Report from 8 November 2017

Kings Hill
Kings Hill**5 July 2017****TM/17/01392/RM**

Proposal: Reserved matters for 132 dwellings in Area 1 (junction of Tower View and Kings Hill Avenue) being details relating to the siting, design and external appearance of the proposed buildings, the means of access, drainage and strategic landscaping involving discharge of conditions 1, 12, 13, 19, 20, 23, 37, 38 and 39 of TM/13/01535/OAEA (Outline planning permission for residential development)

Location: Area 1 Kings Hill Phase 3 Gibson Drive Kings Hill West Malling Kent

TONBRIDGE AND MALLING
BOROUGH COUNCIL
THIS IS THE PLAN REFERRED
TO IN THE DECISION NOTICE
DATED
RE: APPLICATION NO

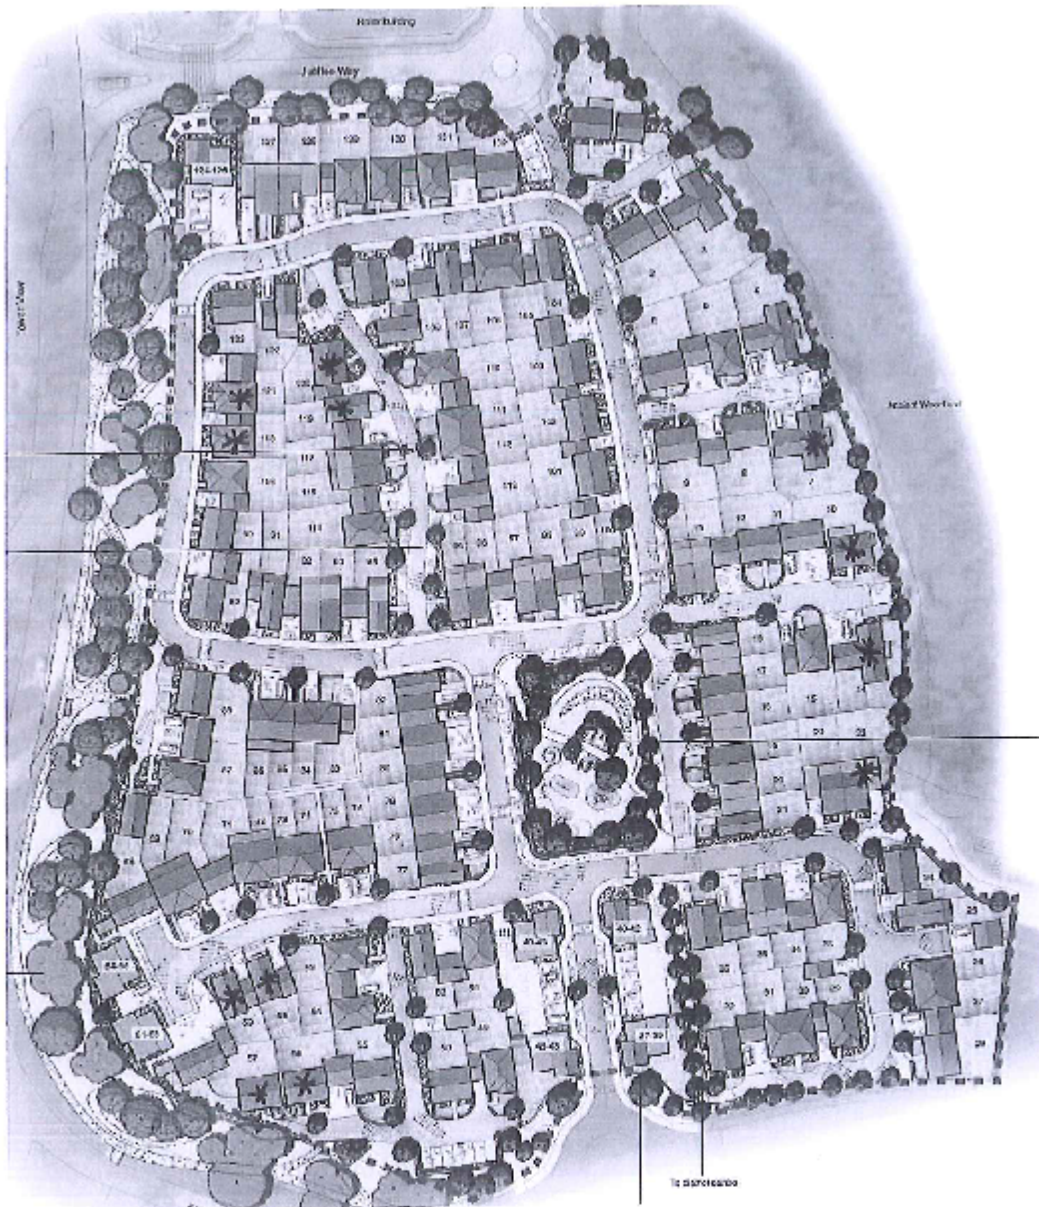
-
5. The windows to the first floor rear elevations of the residential units identified in the attached plan shall be glazed in obscure glass and shall be non-opening below a height of 1.7m measured from the internal finished floor level prior to first occupation. The windows thereafter shall not be altered in any way without the prior written approval of the Local Planning Authority.
